231216_Submission - DA2023-1678

Re DA 2023-1678 - 1 Cutler Rd Clontarf Objection.

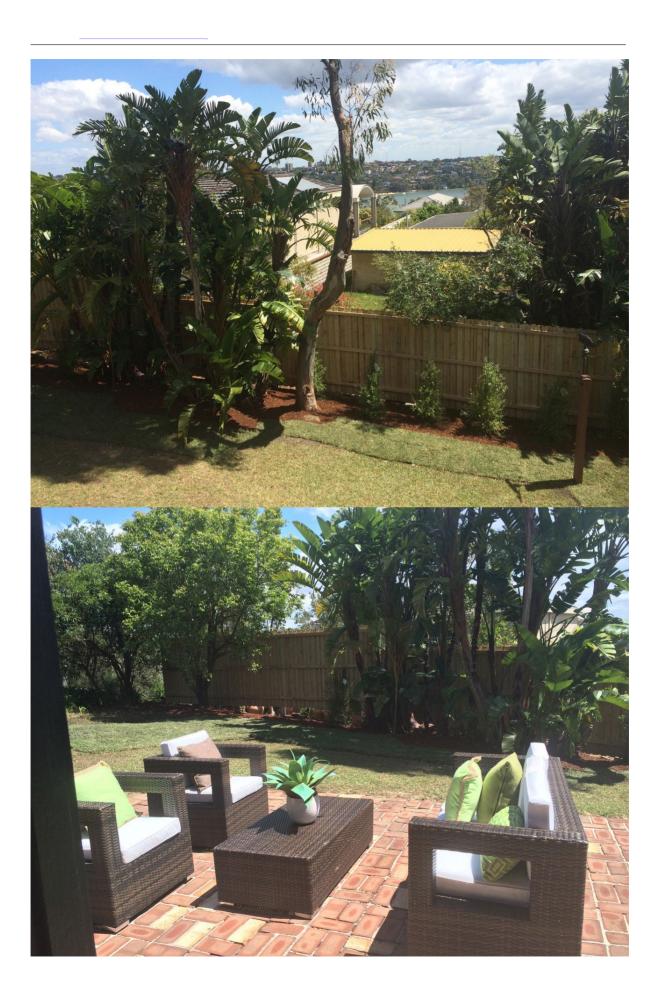
- There is very little detail regarding this proposed pool, other than just an outline of the pool a pencil line wide. It is probably a concrete pool structure, however there are no specific details. As an engineer I am aware of what occurs with pool construction.
- The new pool wall construction will be significantly closer to the Paling fence, as well as above the height of the old retaining wall. We note that one of council documents has mentioned they will need to provide capture & pumping of water back to Cutler Rd, but there are also likely to be substantial changes to the underground flow of water with the new pool installation. Where is this pump and equipment to be located? What are the noise levels?
- With the proposed new pool deck RL61.13, people standing on the pool deck, will also be able to look into, the rooms mentioned above, on the eastern side of our house.

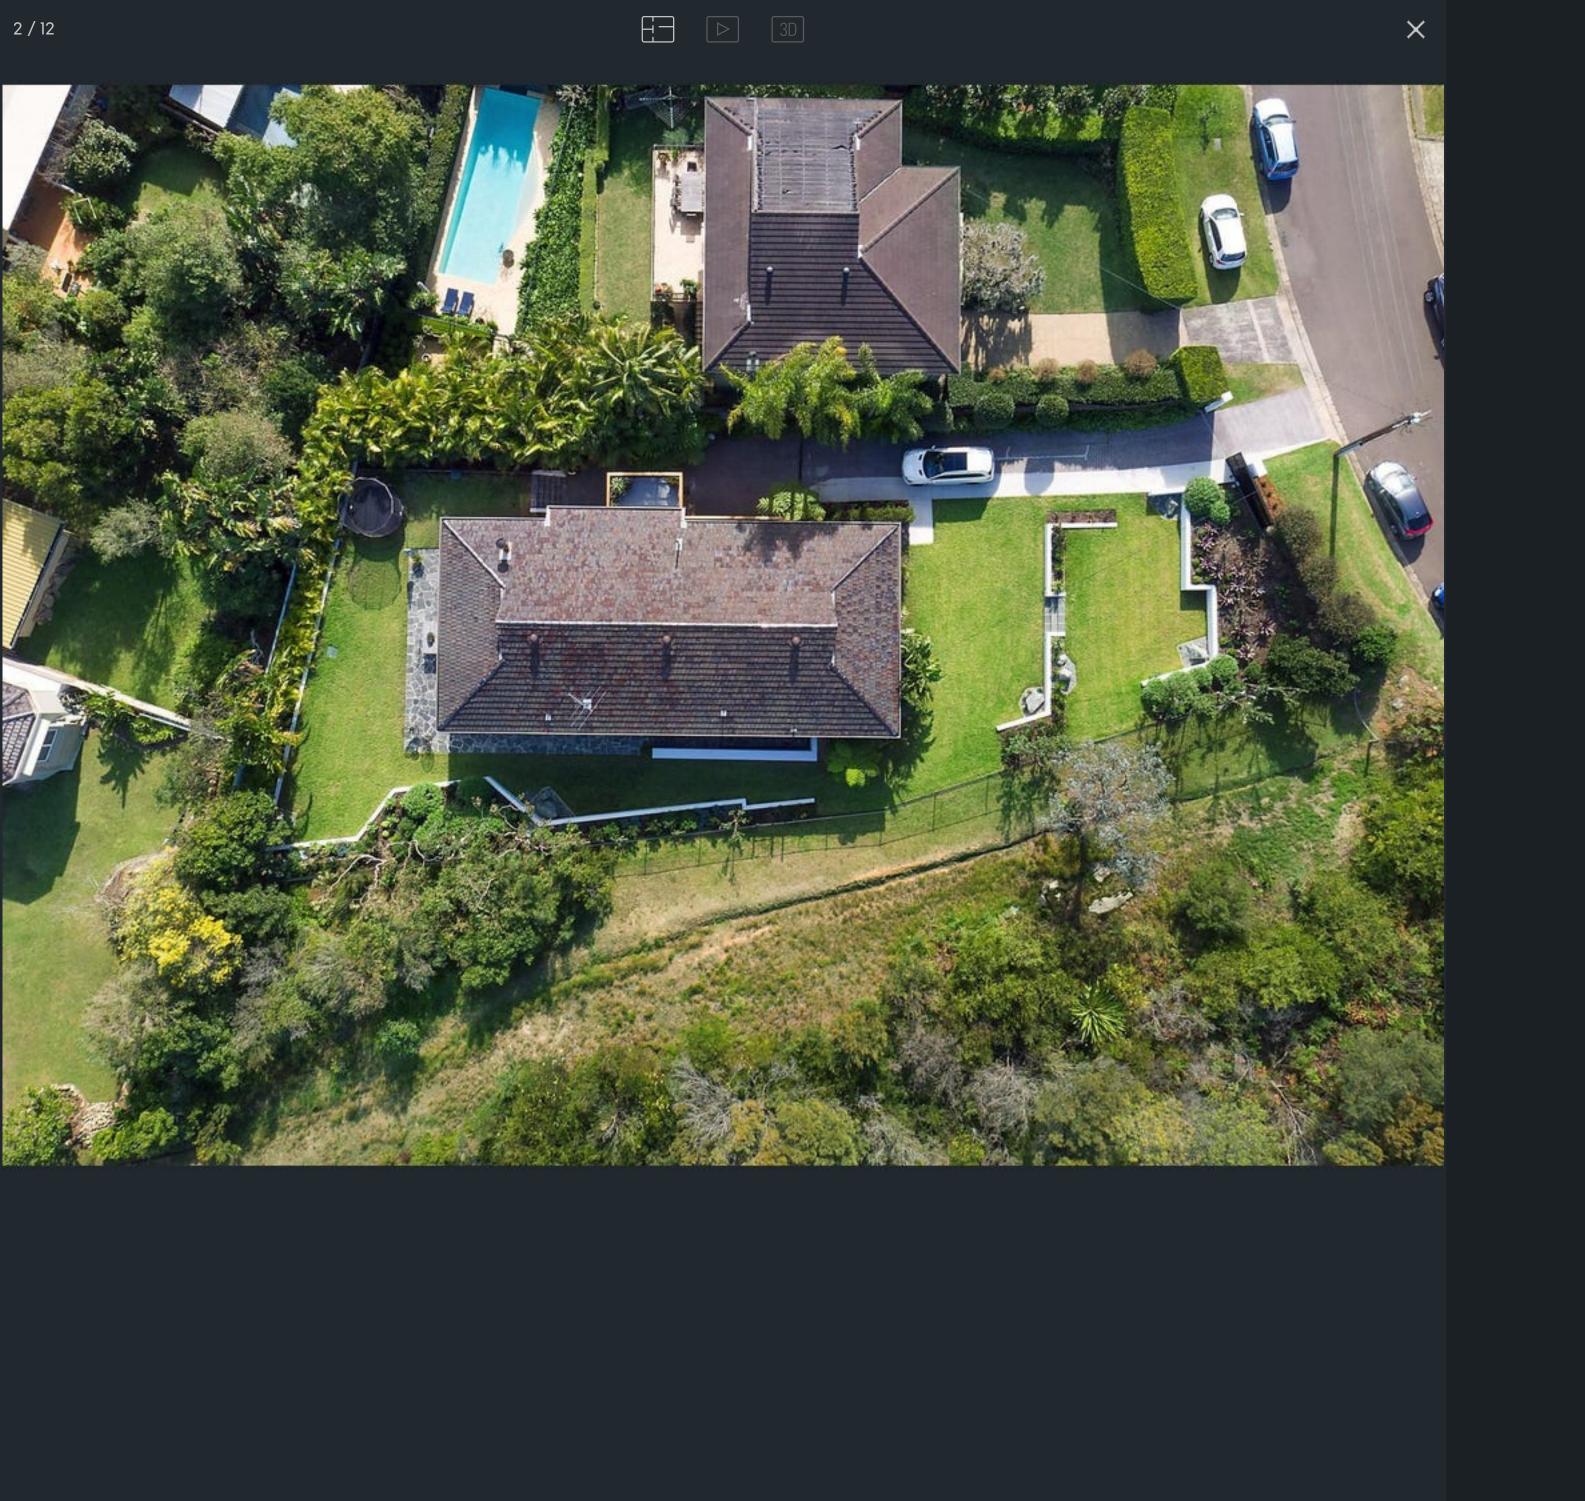
- **1. Investigate** the apparent unauthorised construction of retaining walls and placement of fill to increase the levels of the rear yard.
- **2.** Not allow the unauthorised raised RLs of the rear yard to be accepted as the appropriate RLs to measure from for any proposed consent including the proposed pool.
- 3. Refuse this DA2023-1678. proposal in its current form. OR
- 4. At the very least, Defer the application and council require -
 - Significant design modifications to the DA drawings to resolve each of our objections, particularly invasion of privacy and loss of amenity to our home and its occupants.
 - The proposed pool be relocated elsewhere on the site.
